September 19, 2102

Re: Waiver Request
Richard and Joanne Calatayud
11406 Barley Field Way
Marriottsville, MD 21104

Exhibit A

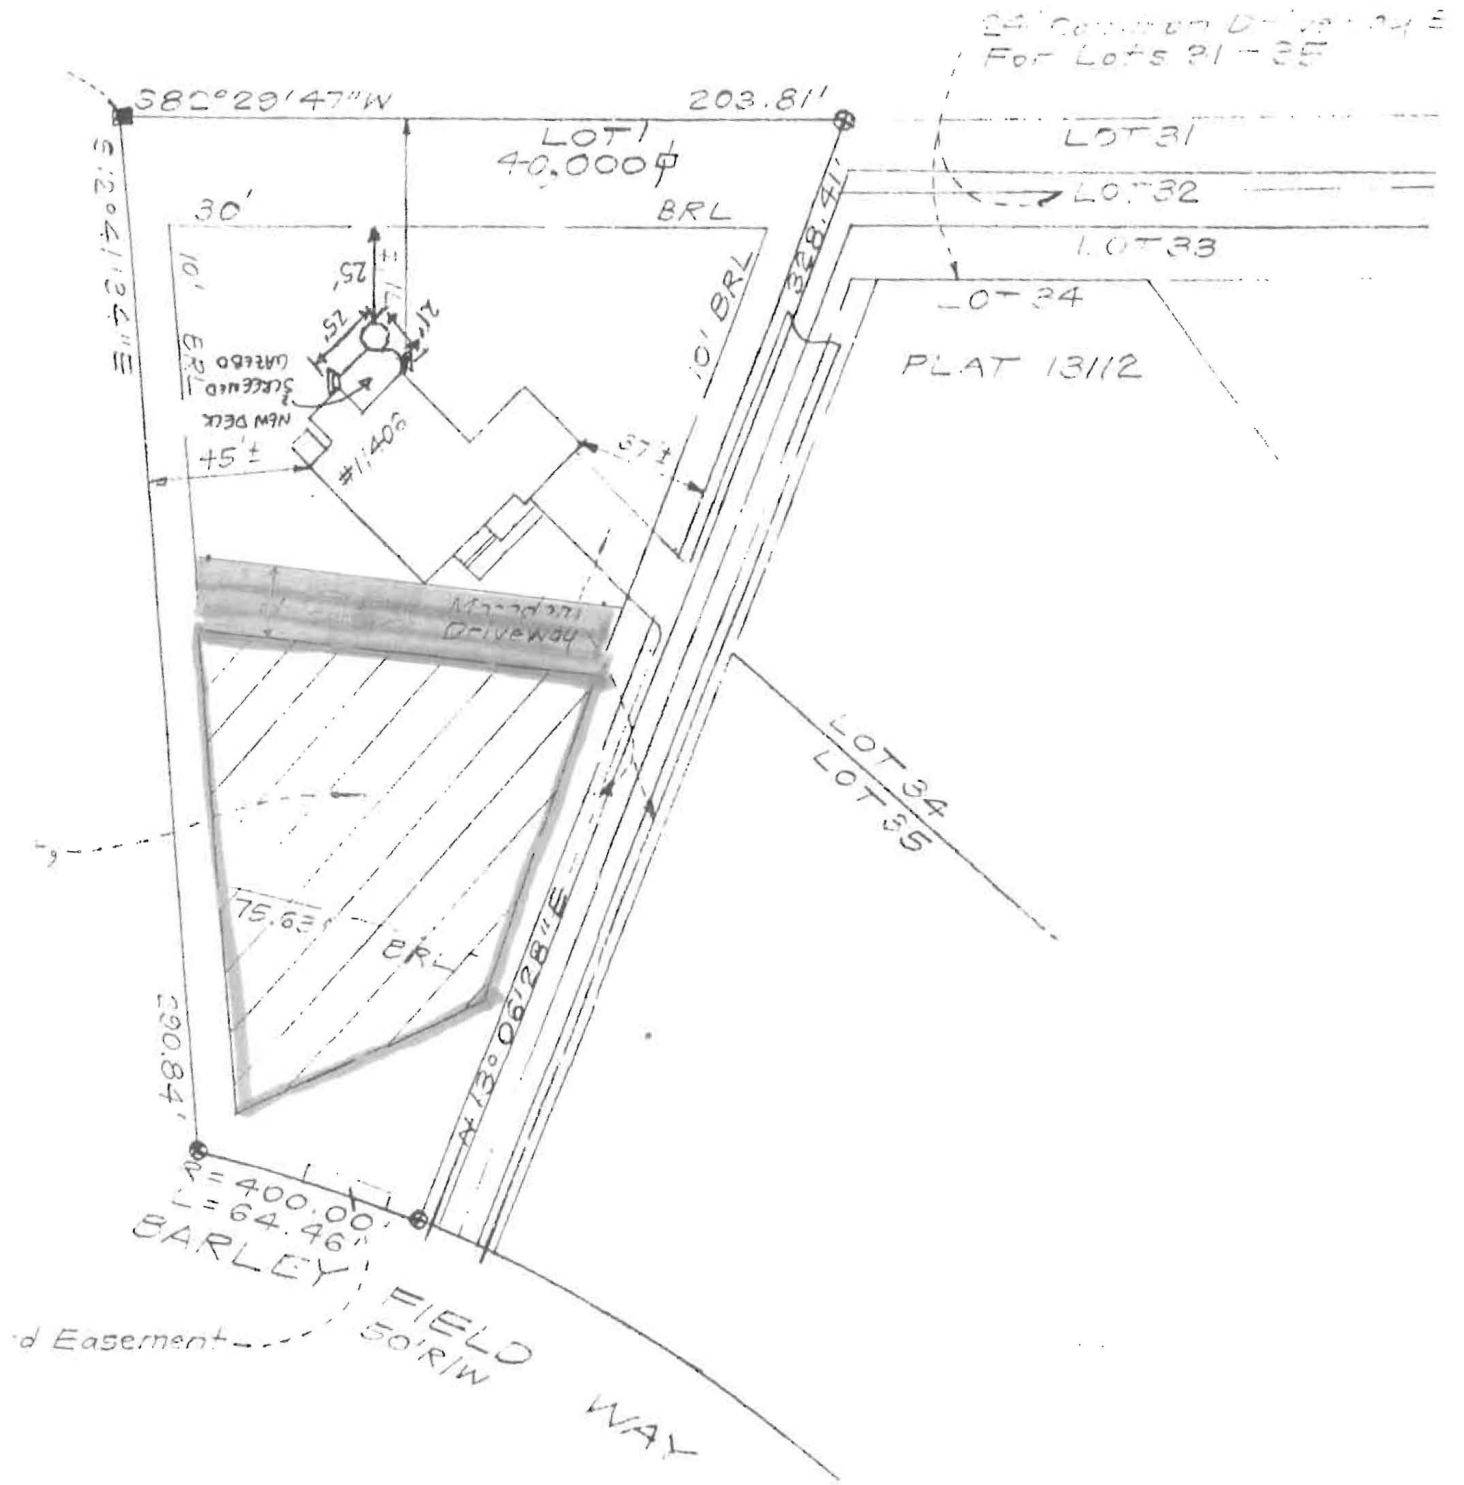
We have retained Design Build Remodeling Group of Maryland as our contractor and Ron Johnston as our architect for the project. During our first design meeting we supplied them with the 'approved' plot plan showing the location of our home and the 10,000 square foot septic reserve area (SRA). This is listed as Exhibit A. This document indicates that the front corner of our home is located approximately 20' from the boundary of the SRA. Our original idea was to file for a waiver to reduce the setback from the SRA from 20' to 10' and to build a stepped-in addition along this new setback line. Exhibit B illustrates our plan, showing the proposed setback in orange with the foundation of the addition outlined in yellow. This plan provides for a 788 square foot single story addition over crawlspace to be built within the modified setback.

10/24/12
Approved
Spt. to
prop. loan
MJD
